SERVICE BULLETIN

APPLICABILITY: 2023-24MY Legacy 2.4L
 2023-24MY Outback 2.4L
 2023-24MY Ascent
 2023-24MY WRX

NUMBER: 16-150-24
DATE: 09/13/24

SUBJECT: Transmission Control Module (TCM) / Software Enhancement

Reference: Judgement Criteria

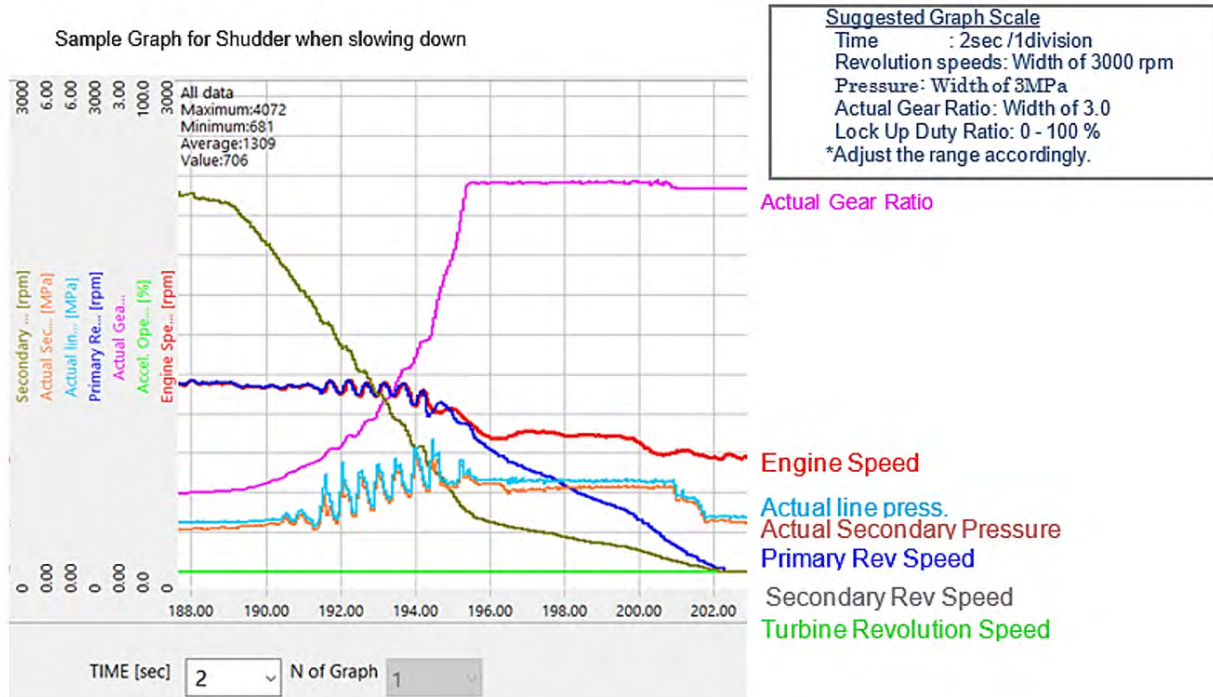
Actual line press. and Actual Secondary Pressure are fluctuating while feeling shudder when slowing down

SYMPTOM 2:

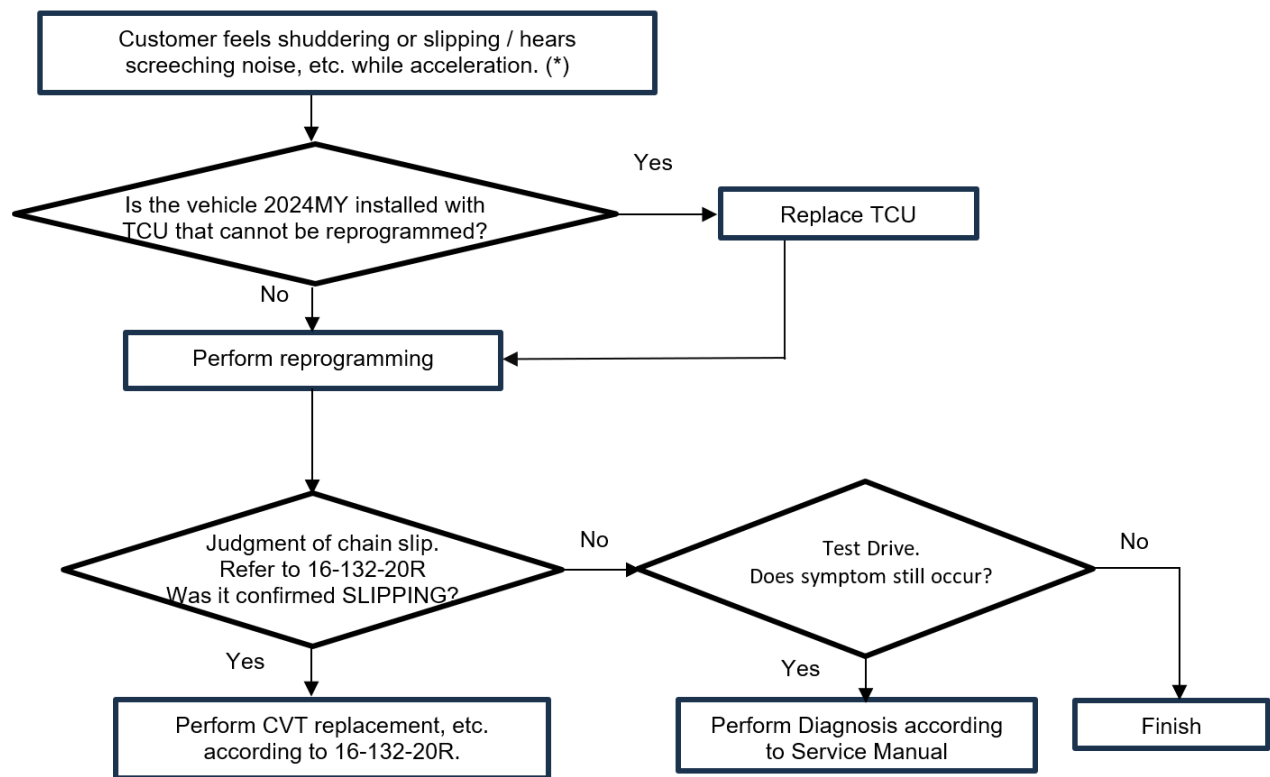
(*) **NOTE:** In case of chain slip caused by input clutch slip, customers may experience symptoms under the following driving conditions.

- (1) Constant speed driving between 25 and 62 mph.
- (2) Gentle acceleration between 25 and 62 mph.

- All of the following are satisfied.
- Primary UP Duty > 80 %
 - Actual Pulley Ratio changes to Low
 - Above conditions last for 0.5sec or more
